Jefferson County, Missouri
Planning and Zoning Commission
Meeting Date: September 9, 2021

Staff Report

Petition Number: PR121067
Petition Name: The Timbers

To: Sam Hoyt, Planning Division
From: Chris Ehlen, Public Works
Re: The Timbers

The Timbers
 DEVELOPMENT PLAN
 Jefferson County, Missouri

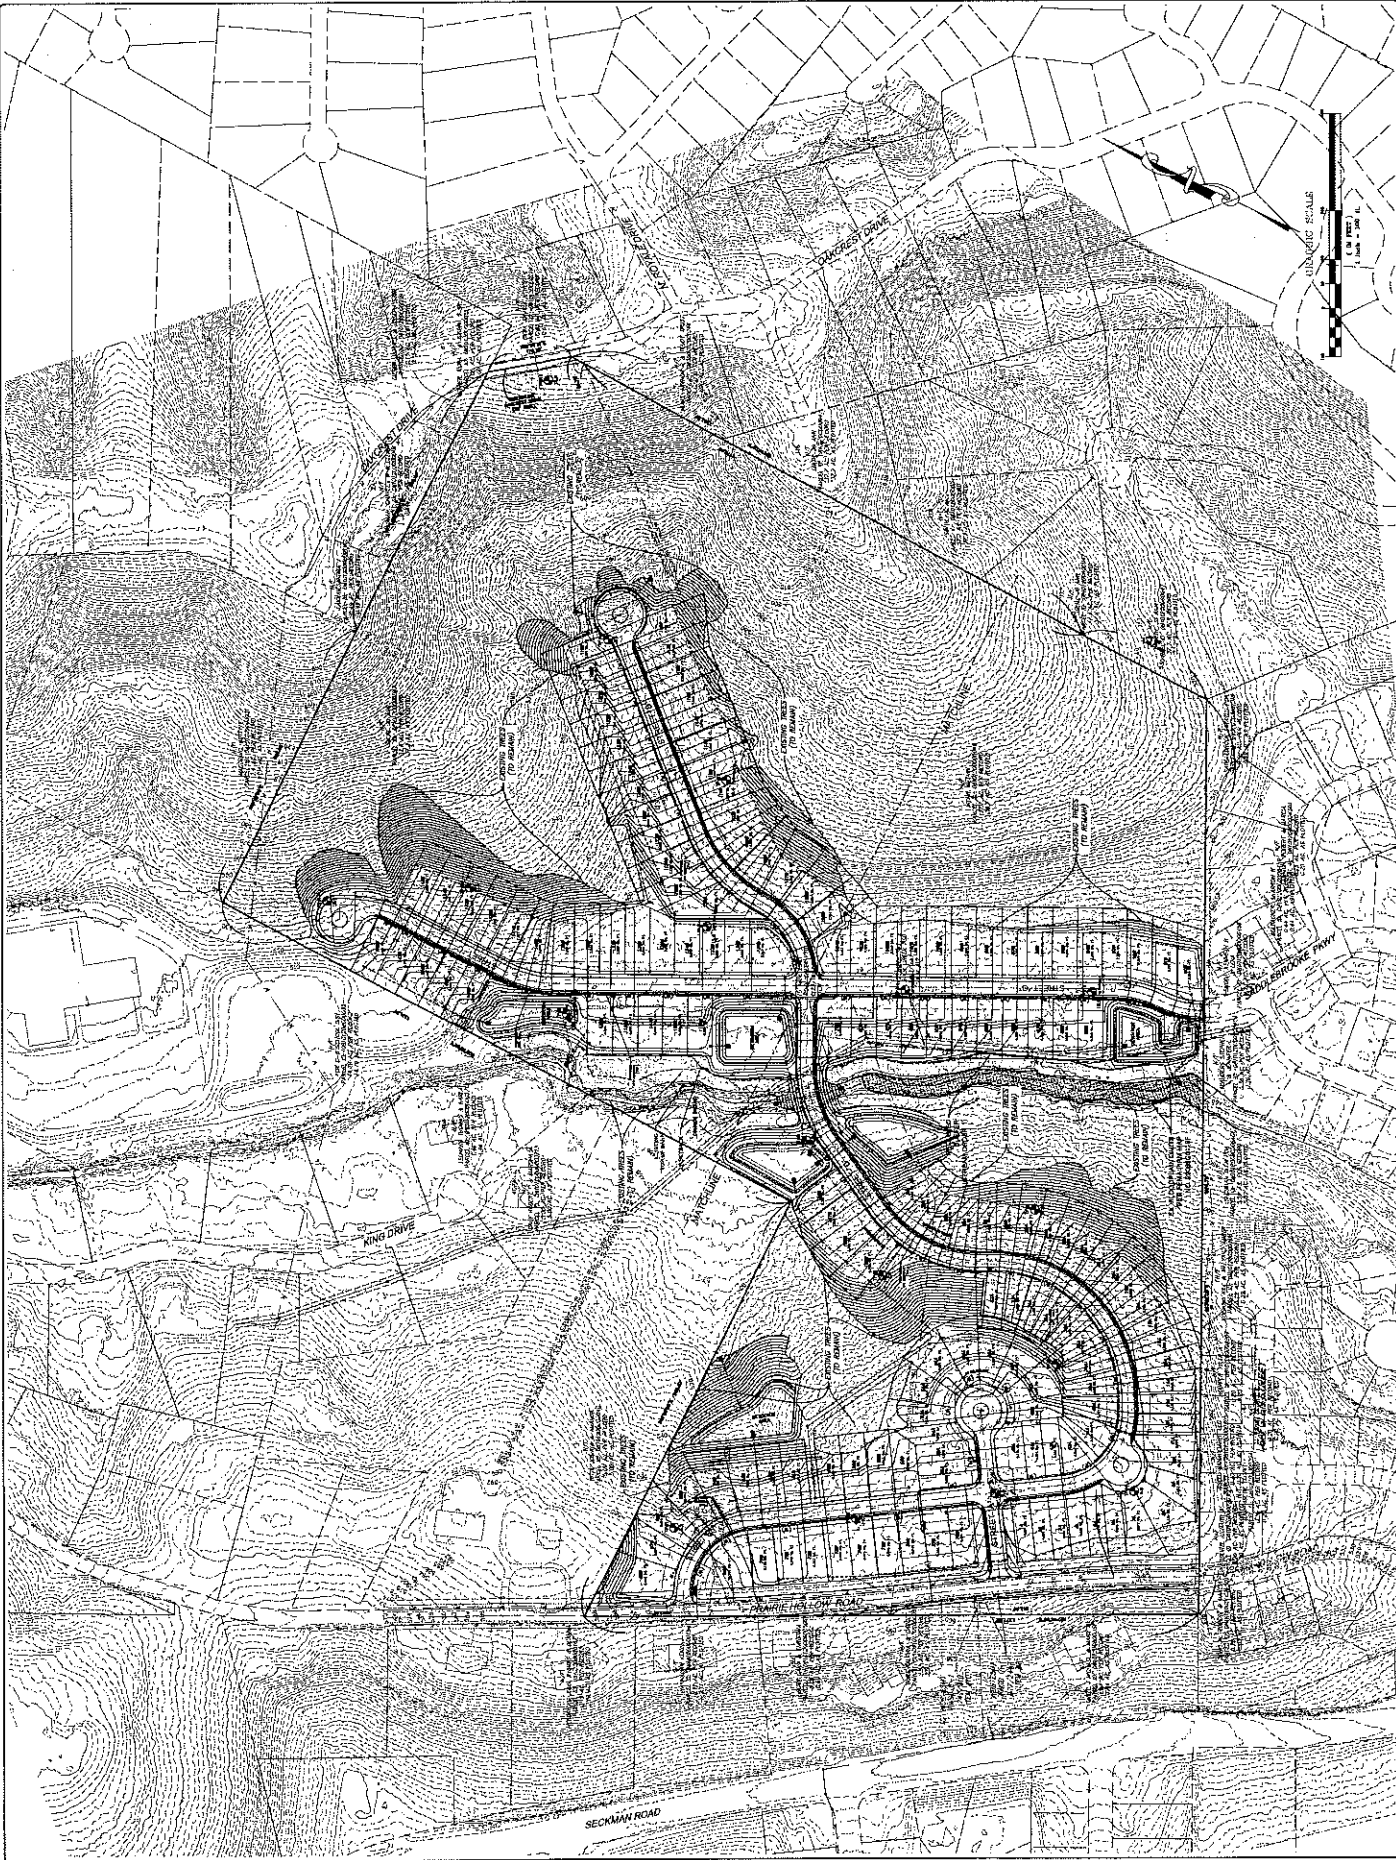
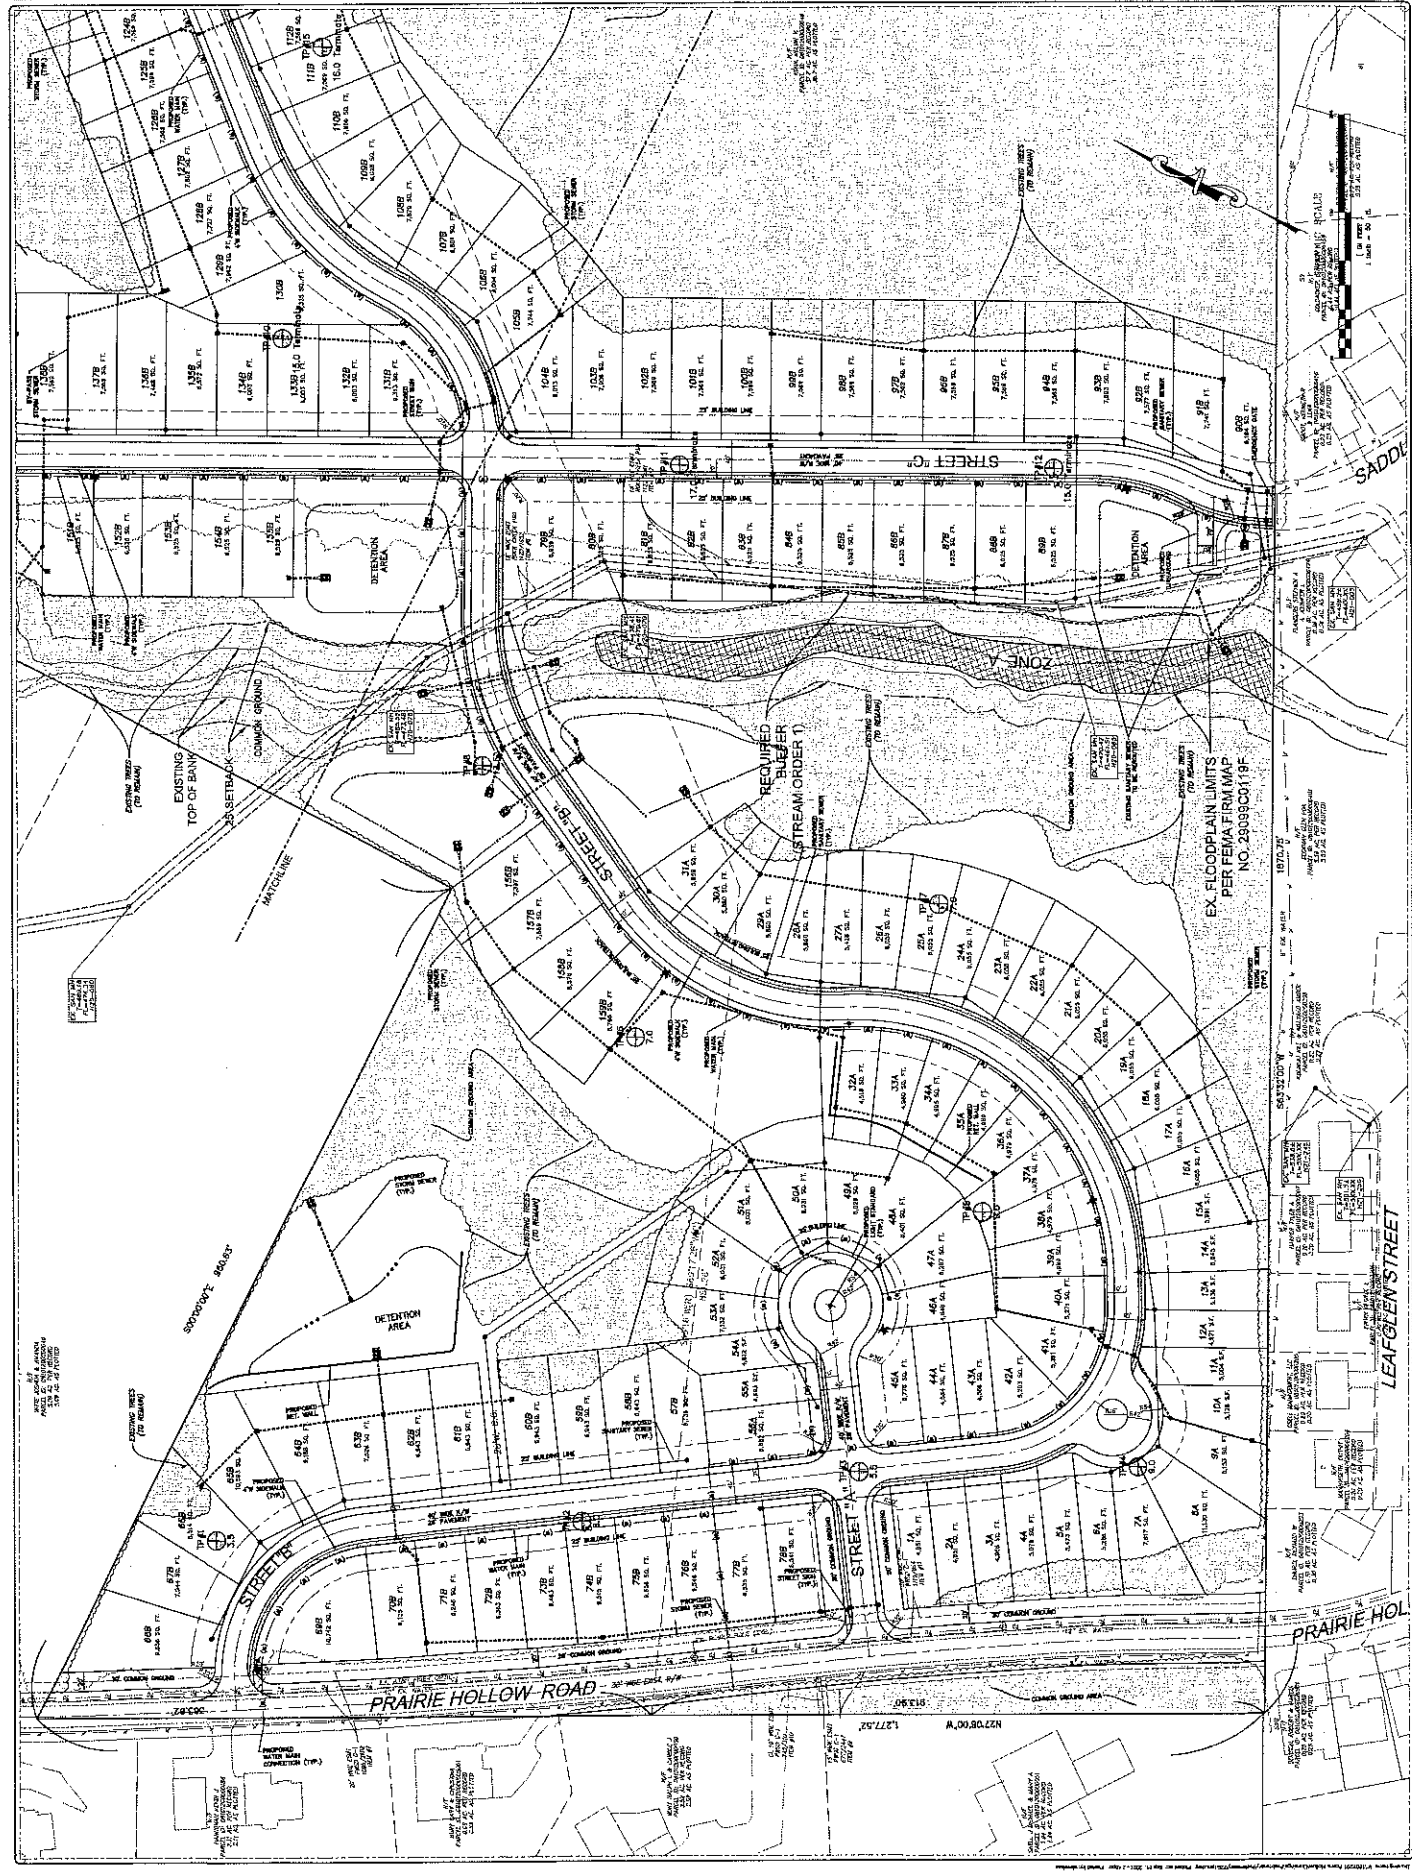
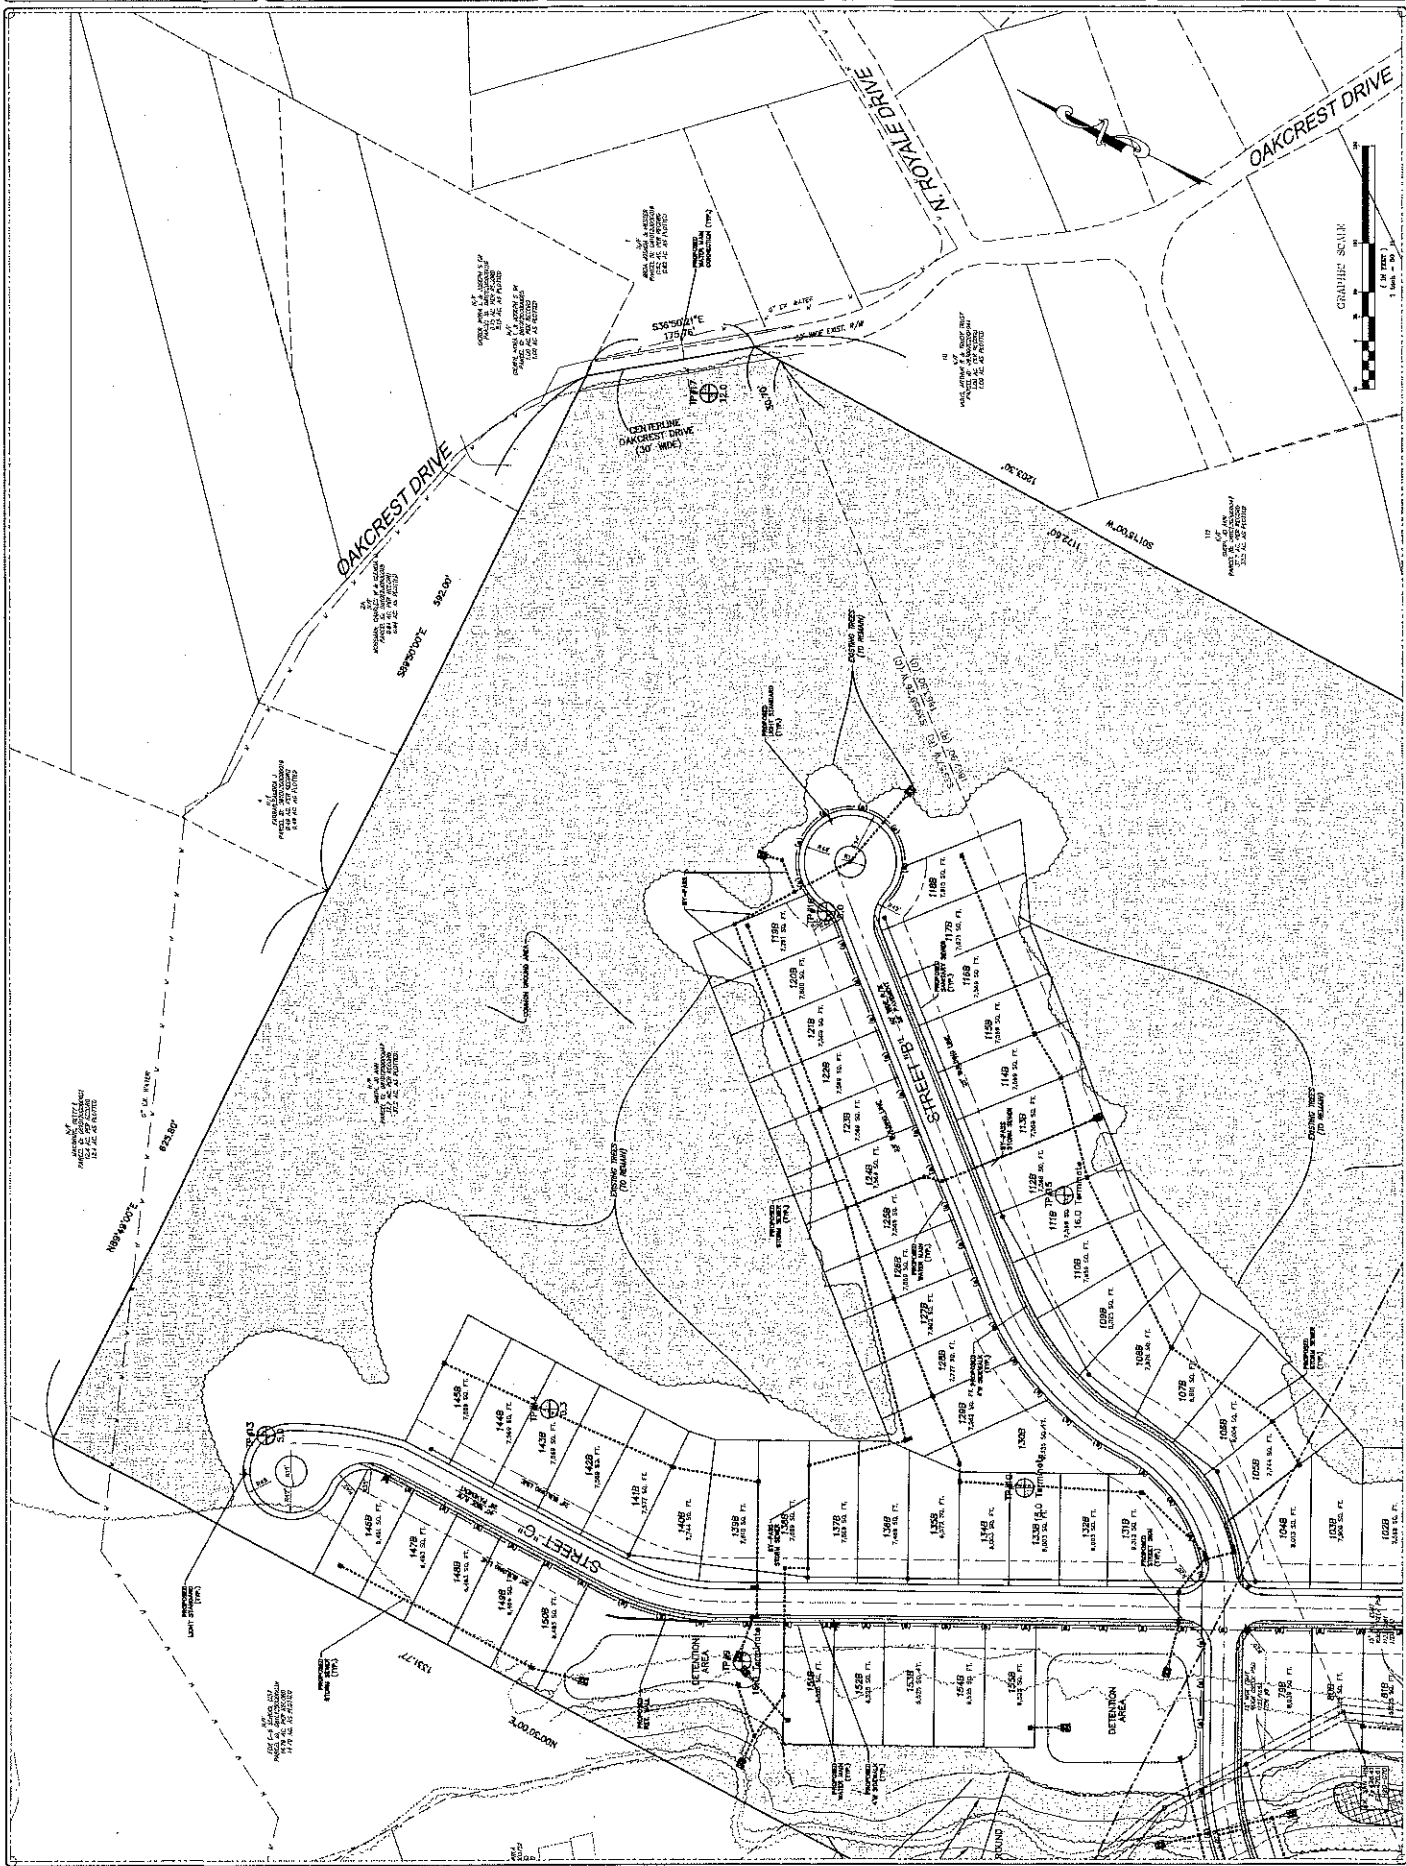
1. Water from Prairie Hollow is sheet flowing onto the common ground and lots. This is likely to lead to future stormwater complaints from the homeowners. This is especially evident at the North End.

- i) Where more than one entrance is required, only 65% of traffic is allowed to utilize any entrance. Condition is not met.

1. Please show sight distance for street "B" Right. We're not sure why this is specified as a right in / right out only intersection. If it is due to inadequate sight distance, the measurement still needs to be shown. County sight distance requirements is 300ft. for these entrances in each direction.
2. There is concern regarding compliance of the right in right out only at street "B".
3. Water from Prairie Hollow is sheet flowing onto the the common ground and lots. This is likely to lead to future stormwater complaints from the homeowners. This is especially evident at the North End.
4. Public Works requests 48hr. notification before any work is to take place within county right of way. Call Brian Stotler at 314.560.5547
